Updates to Increase Top Speed

Classification	Repair Bulletin	Section/Group	40 - Rear Drive Unit	Country/Region	All
Year	2014-2015	Model	Model S	Version	85, P85D

Figure 1 (Revision level highlighted)

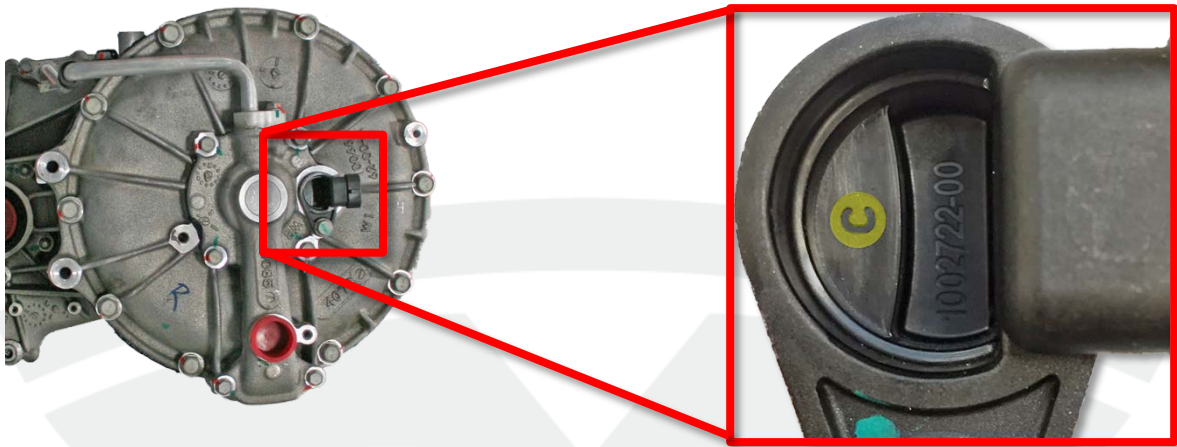
2. Use a mirror or borescope to check the part number on the rear drive unit motor speed sensor (Figure 1).
 - If the part number is 1002722-00-B, replace the speed sensor with revision C or later (refer to Service Manual procedure 40102002), then continue to step 3.
 - If the part number is 1002722-00-C or later, continue to step 3.
